CCB 7196.016
Pre and Post Change Summary
PCN #: MAAN-25PKAF930

Pre and Post Change Summary - TUBE

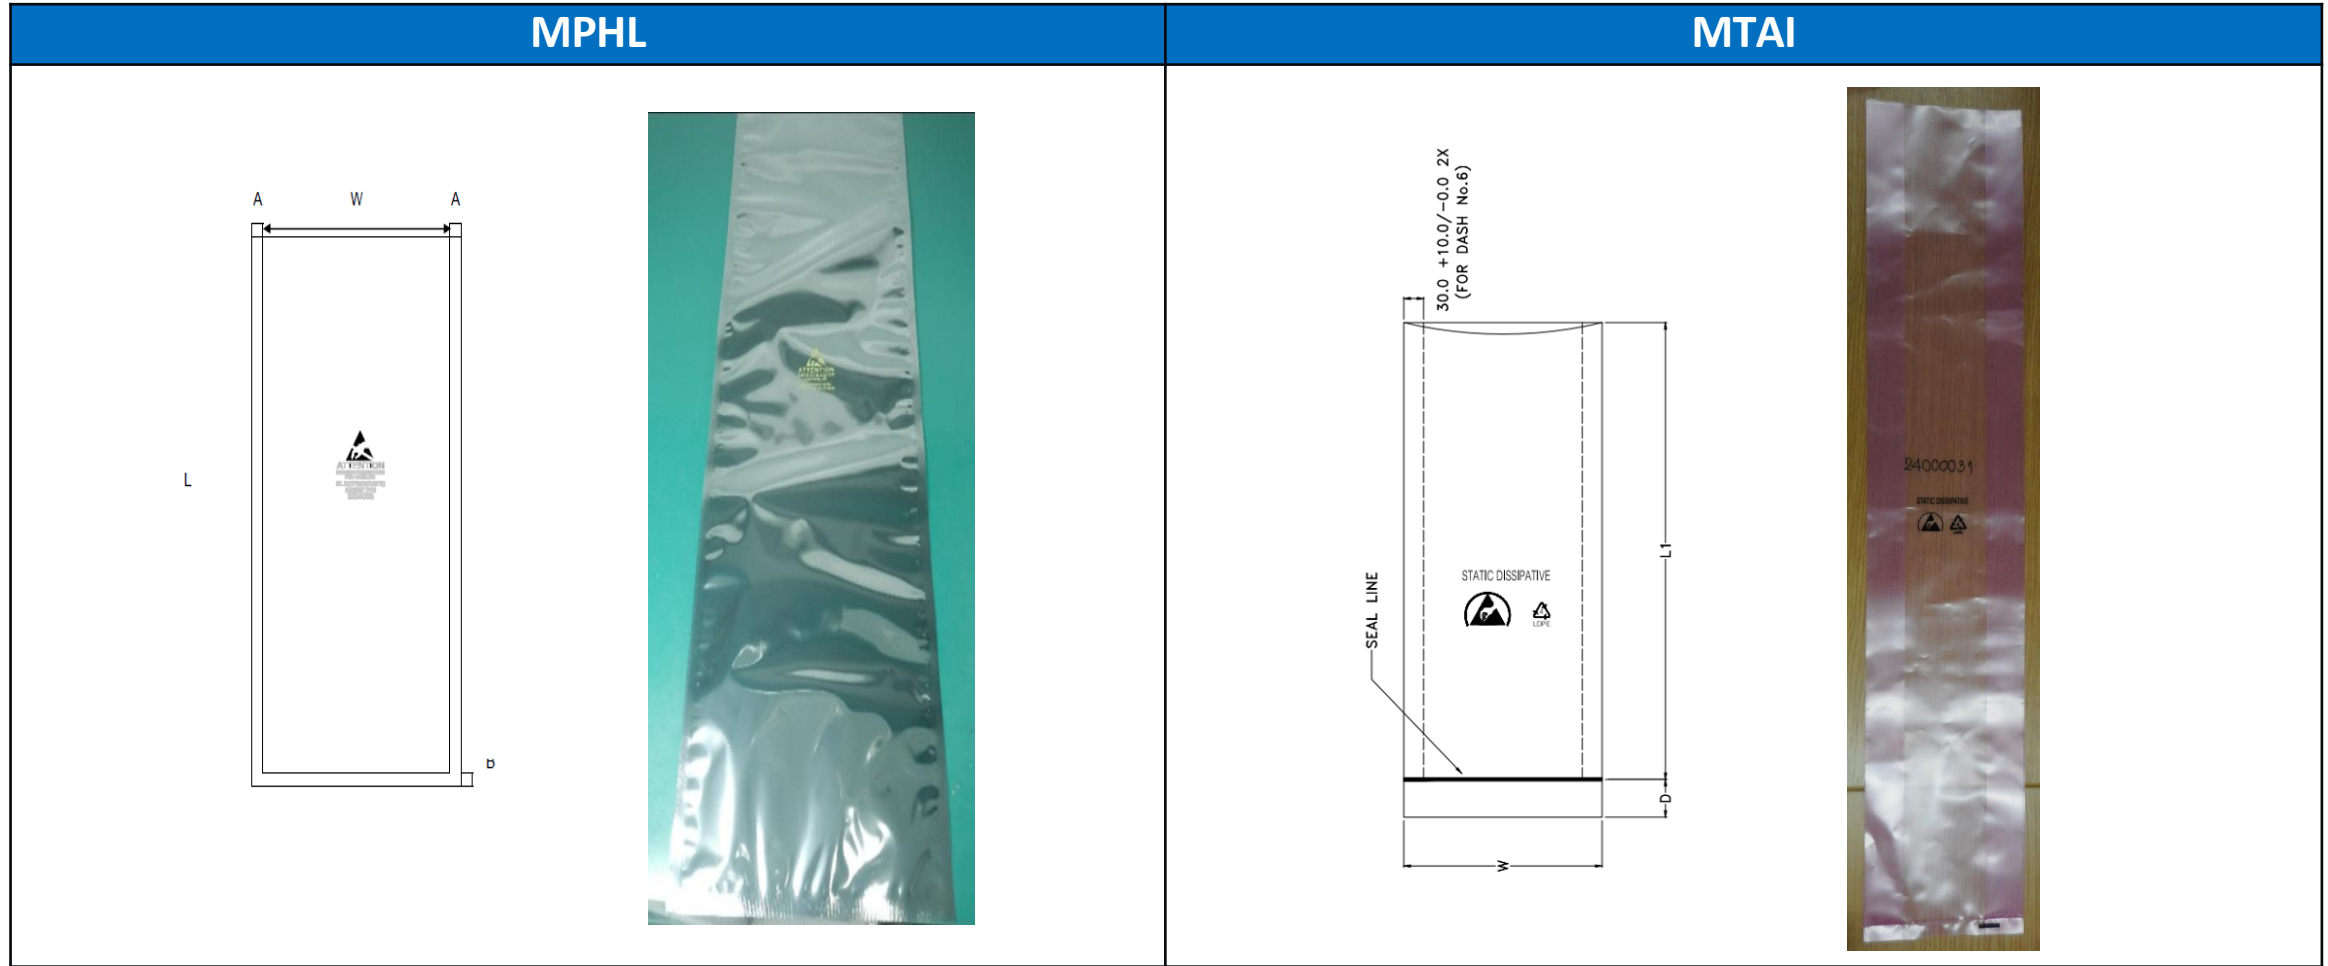
Location	Tube Length (inch)	Dimension	Tube Length between Hole Usage	Unit per Tube	Tube per Bag	Tube Color
MPHL	20.33 +/- 0.030	See on drawing	19.53 +/- 0.030	18	40	Transparent Clear
MTAI	20.33 +/- 0.030	See on drawing	19.53 +/- 0.030	18	40	Transparent Clear

Pre and Post Change Summary - TUBE (Bag)

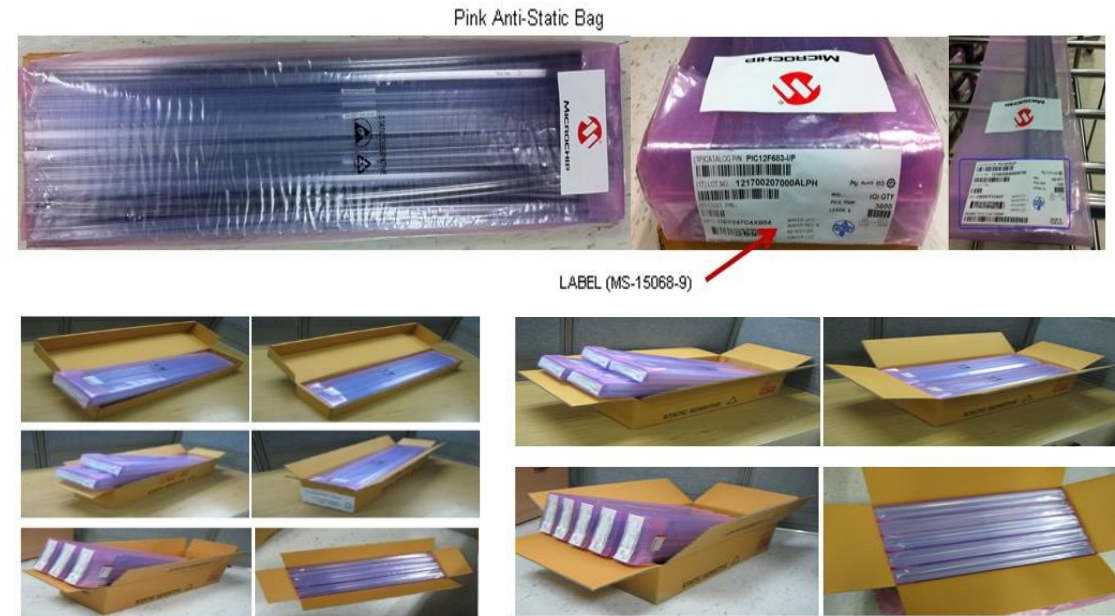
Plant	Bag type	Length (mm)	Width (mm)	Thickness (mm)
MPHL	Static Shielding Bag (Gray)	762 +/- 10	228 +/- 10	0.08 +/-0.01
MTAI	Antistatic Pink Gusset	760 +10/-5	140 +10/-0	0.100 +/- 0.01
